# United States Patent and Trademark Office

APPLICATION N	O.	FILING DATE	FIRST NAMED INVENTOR	ATTORNEY DOCKET NO.	CONFIRMATION NO.	
10/808,408		03/25/2004	Naoya Tanikawa	000409-097	000409-097 5116	
21839	21839 7590 10/04/2005			EXAMINER		
		GERSOLL PC	BOLTON, TARA L			
•		RNS, DOANE, SWECK Y 1404	ART UNIT	PAPER NUMBER		
POST OFFICE BOX 1404 ALEXANDRIA, VA 22313-1404			3681

#### **DETAILED ACTION**

1. The following is a first action on the merits of application 10/808,408 filed on 03/35/2004.

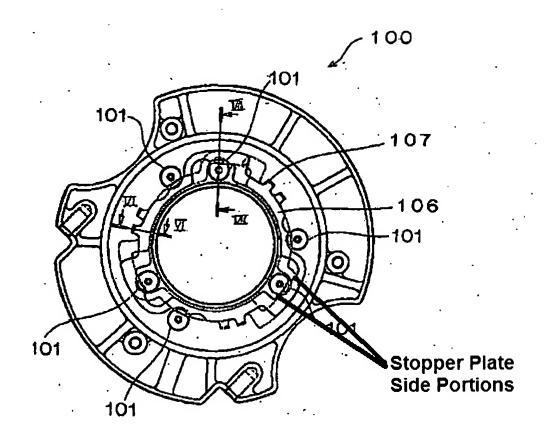
- (b) the invention was patented or described in a printed publication in this or a foreign country or in public use or on sale in this country, more than one year prior to the date of application for patent in the United States.
- 6. Claims 13-15 are rejected under 35 U.S.C. 102(b) as being anticipated by the prior art shown in Figs. 4-7 of the present invention.

Claim 13, the planetary gear structure shown discloses a carrier (100) having a cylindrical portion, a plurality of pinion shafts (101) mounted in the carrier (100), a stopper plate (106) with the projection portions of the plate (107) arranged between a pair of pinion shafts (101) to fix the pinion shafts (101)against revolution about their own axes.

Claim 14, this planetary gear structure shows the stopper plate (106) has side portions (labeled in the drawing below) extending along a radial direction and engaging one of the pinion shafts (101)

Claim 15, the planetary gear structure shown discloses a slit (103) on the pinion shafts (101) for engaging the stopper plate (106).
